AS3243™

BOLT, MACHINE - DOUBLE HEXAGON EXTENDED
WASHER HEAD, DRILLED, PD SHANK, NICKEL ALLOY,
UNS N07718, 185 KSI UTS MIN, .1900-32 UNJF-3A

AS3243™
SHEET 1 OF 2REV.
E

FIGURE 1 - BOLT

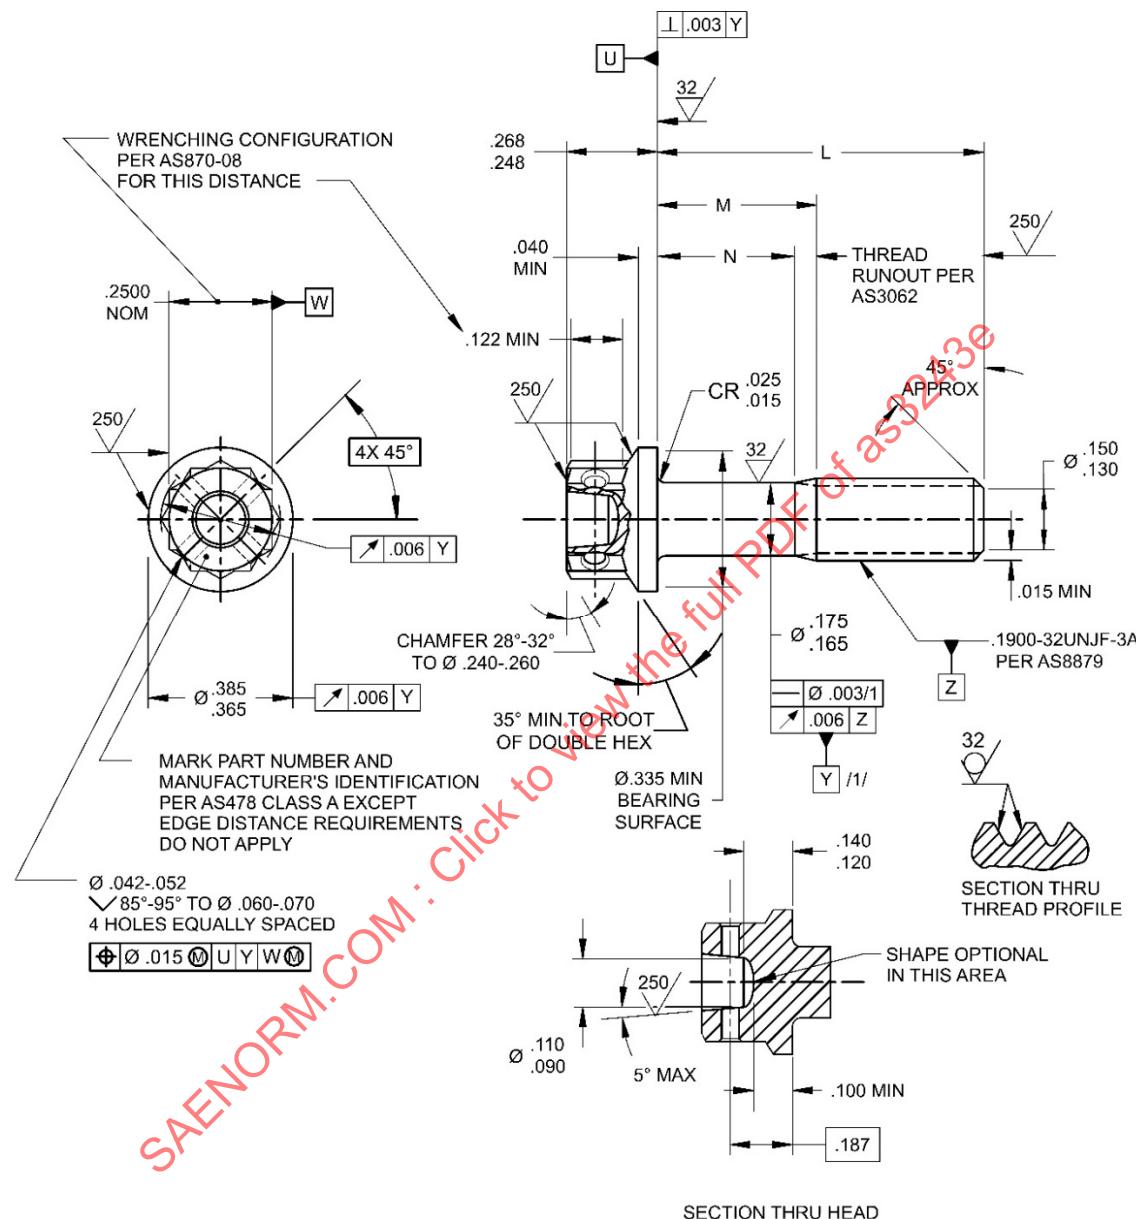
FIVE-YEAR REVIEW. UPDATE TO ASME Y14.5-2018. REVISE HEAD TO SHANK FILLET RADIUS TO "CR." REVISE POSITION REQUIREMENTS FOR SAFETY WIRE HOLES PER AS1132 (ADD A TERTIARY DATUM Y AND REVISE TOL FROM .020 TO .015). ADD "TO ROOT OF DOUBLE HEX" TO ANGLE CALLOUT ON TOP SURFACE OF WASHER PER AS1132. ADDED "COMPOSITION SIMILAR TO" TO UNS IN NOTE 2.
